Downtown Victoria North Manchester.

RIBA Stage 4 Planning Adjustments
12882-AEW-XX-XX-PP-A-0017

BS / BR 09/02/24
P01

Introduction.

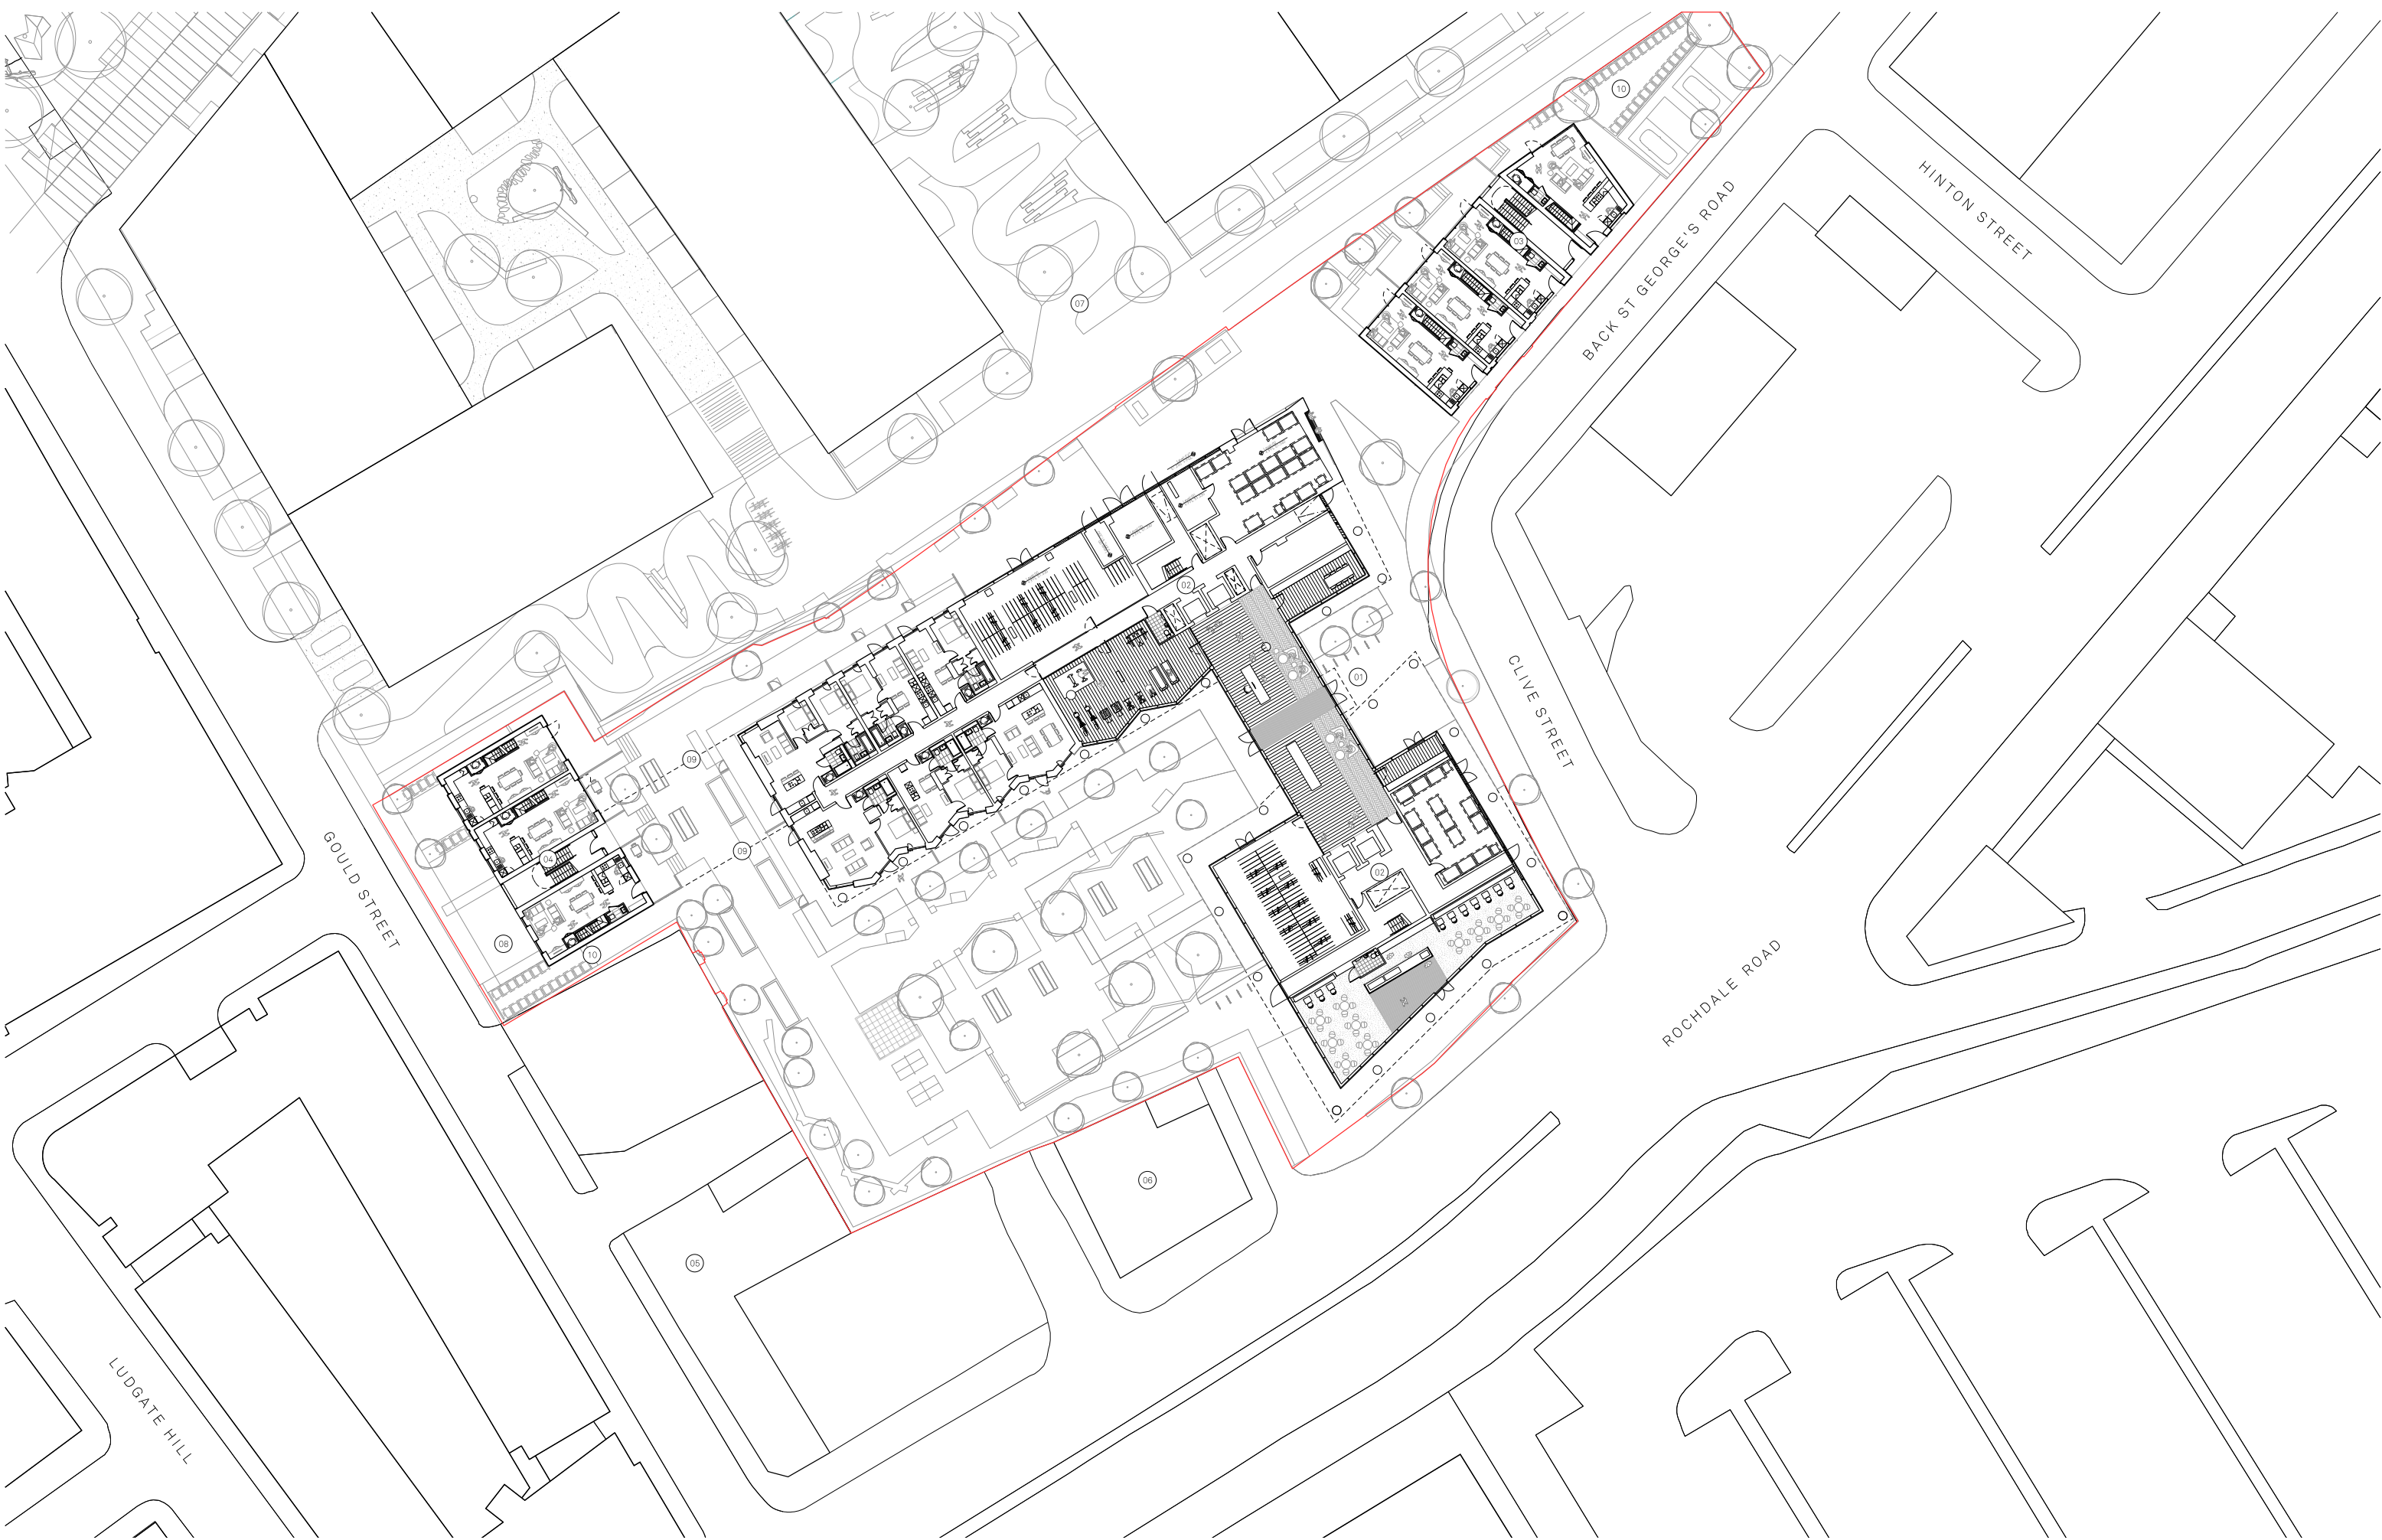
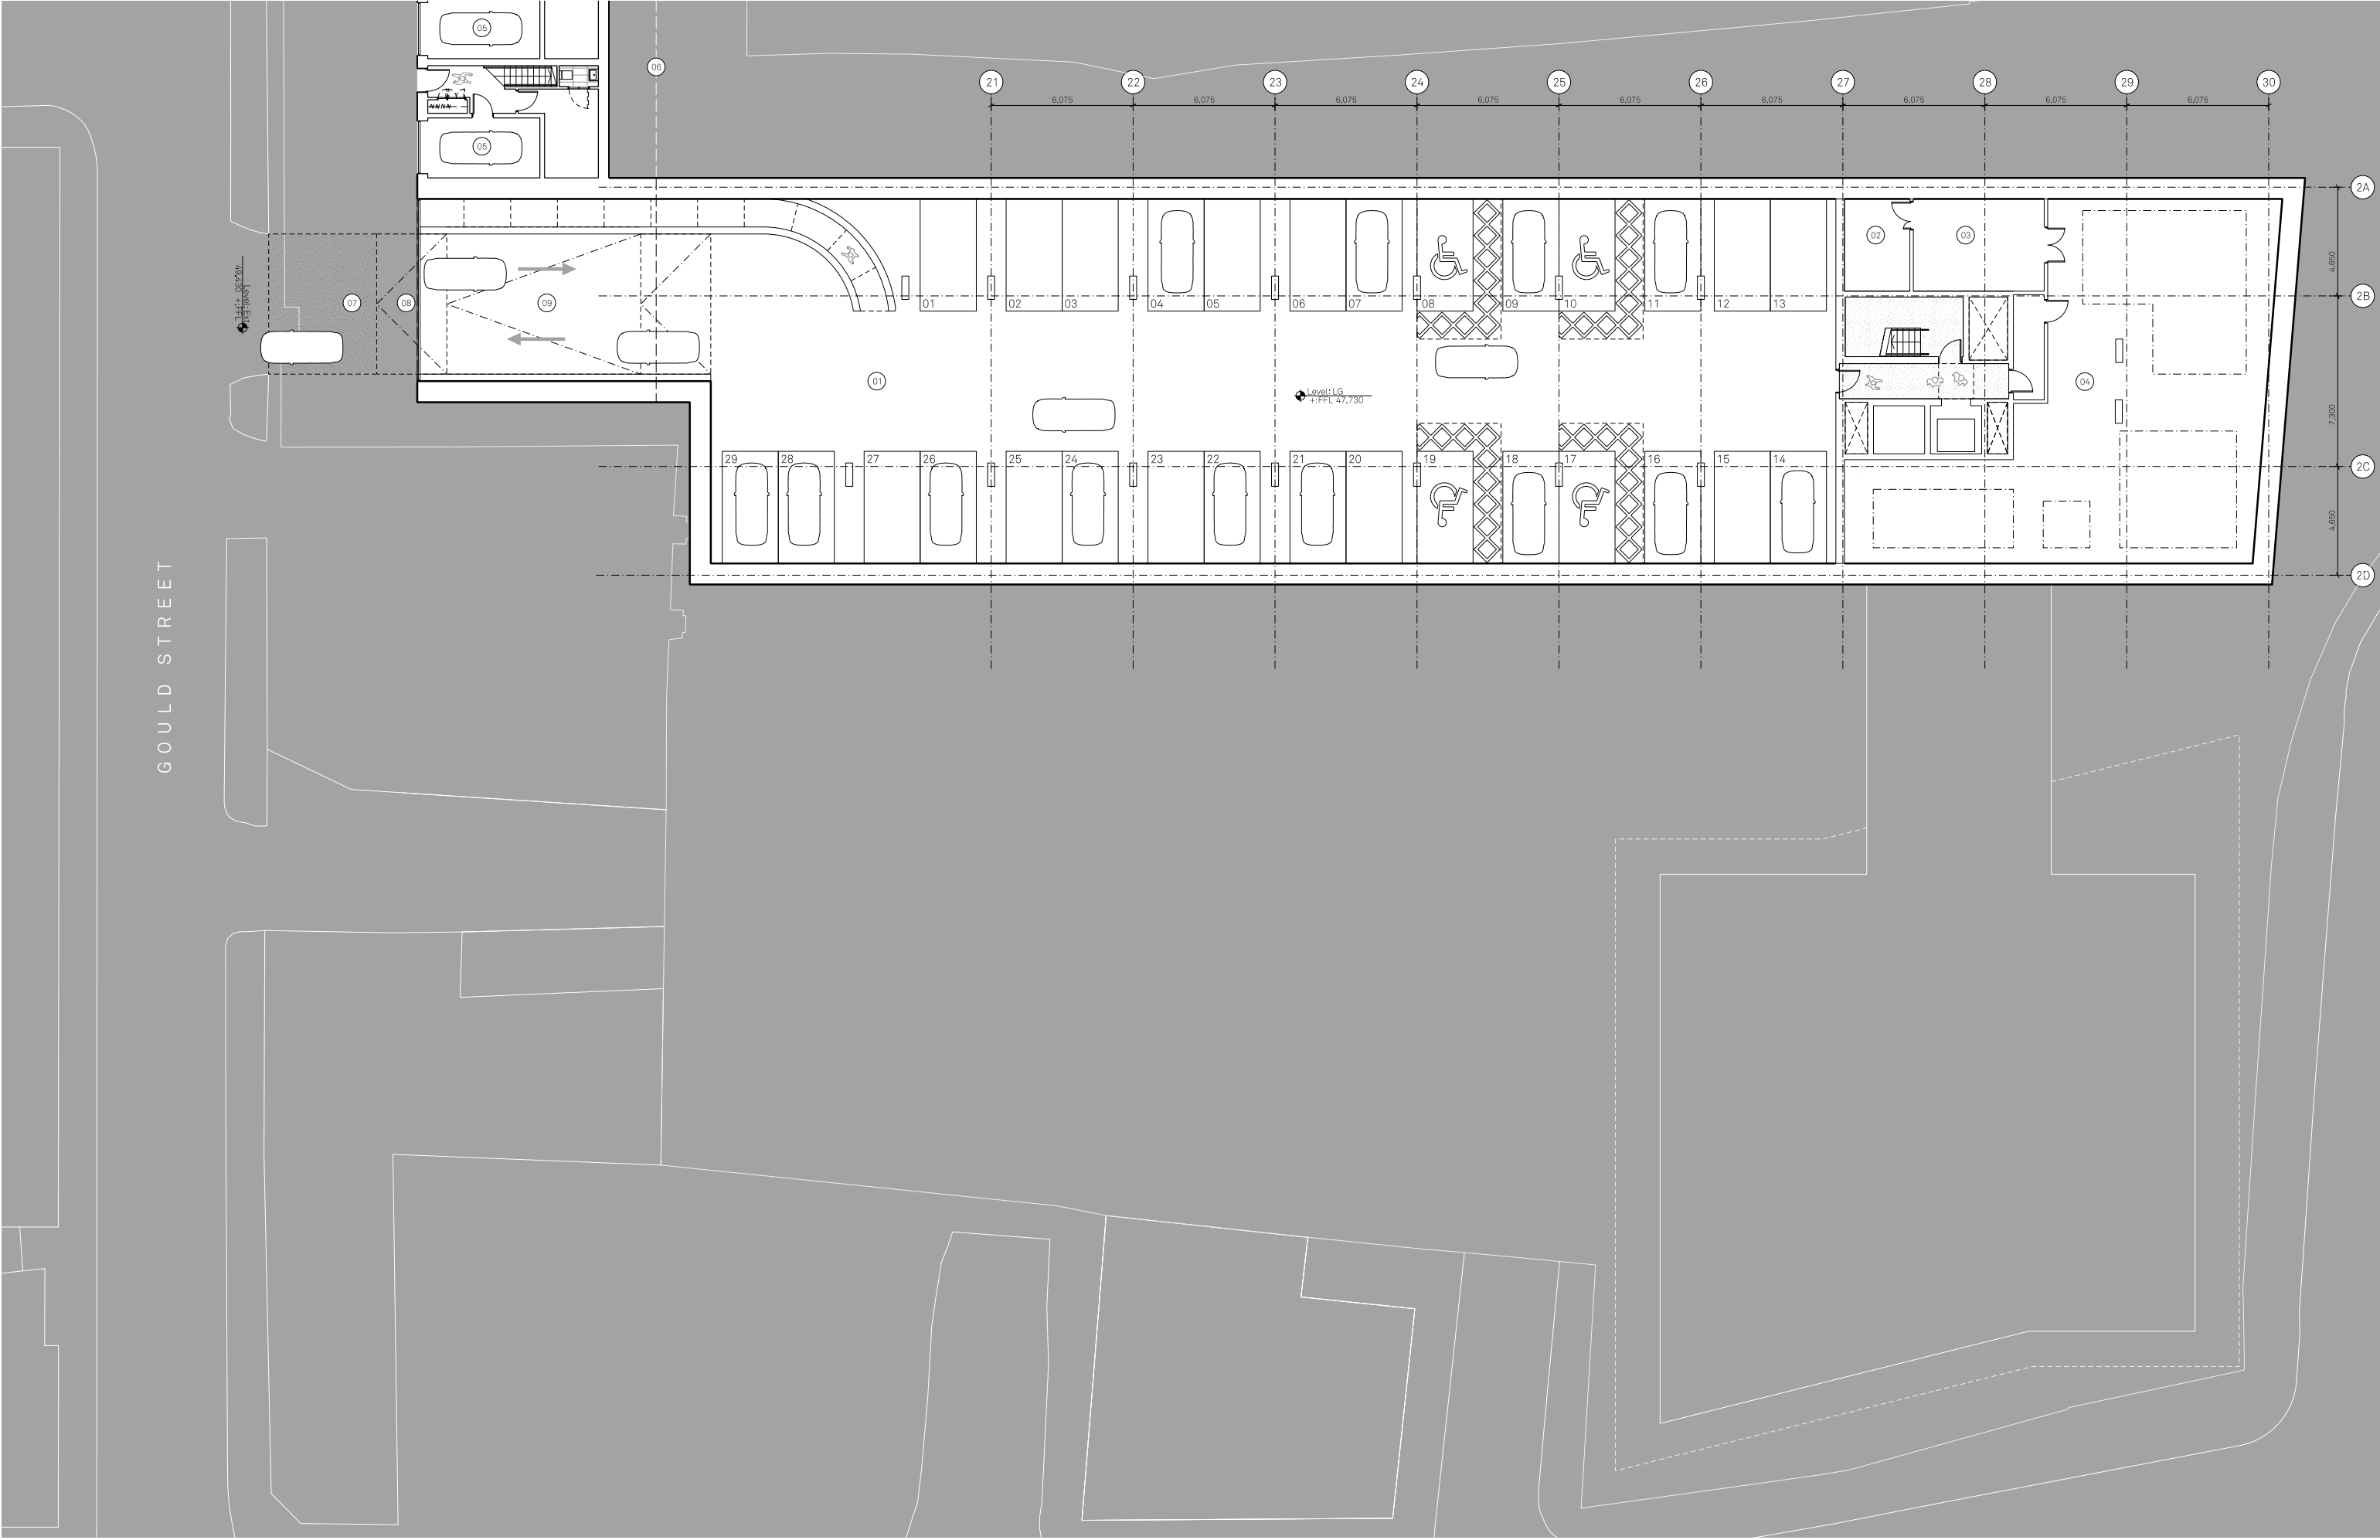
- A** Adjustment to access of Block 3 following review of site levels with approved plan. Access provided for fire fighting purposes
- B** Bin storage re-located to suit above. Condition 20 submission made by MCL
- C** Landscape updated to reflect progressed design
- D** Block 1 layout updated as described in following sections
- E** Boundaries updated to reflect submission of information under Condition 12

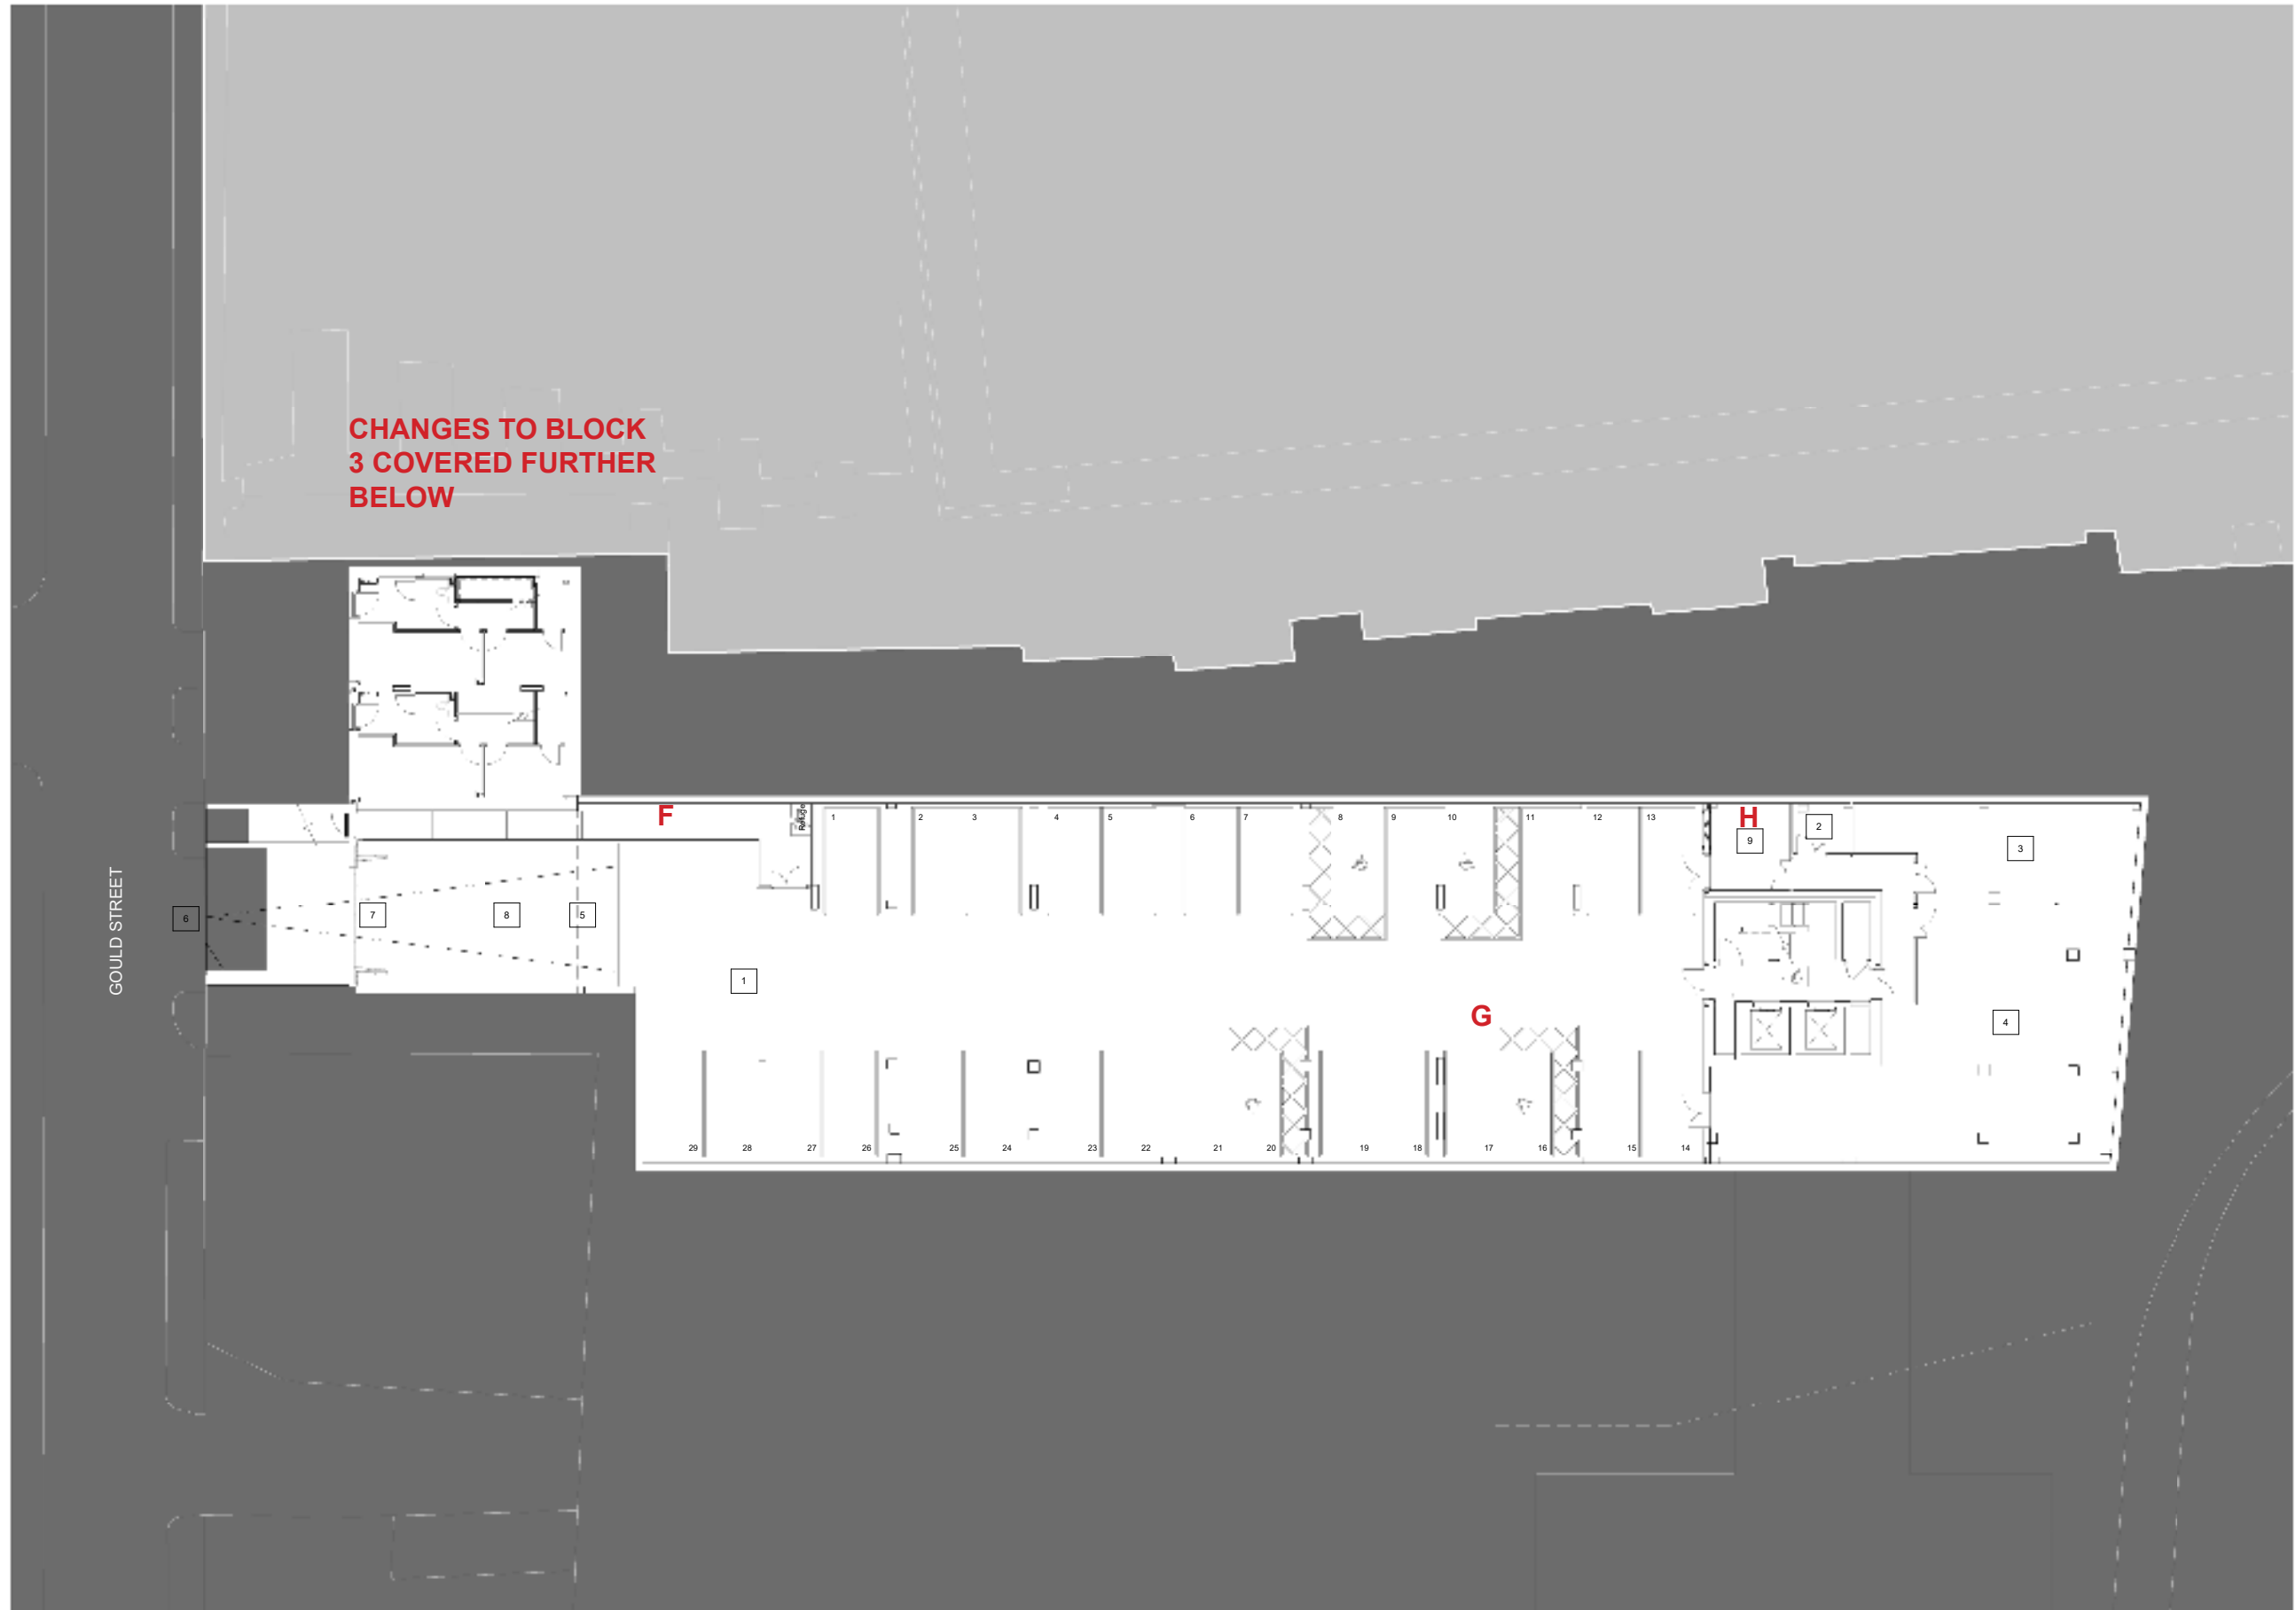
F As part of the developed fire strategy a separate and protected escape route is required out of the basement onto Gould Street. This requires separate pedestrian gate to be provided.

G Accessible parking spaces adjusted to provide suitable manoeuvring space.
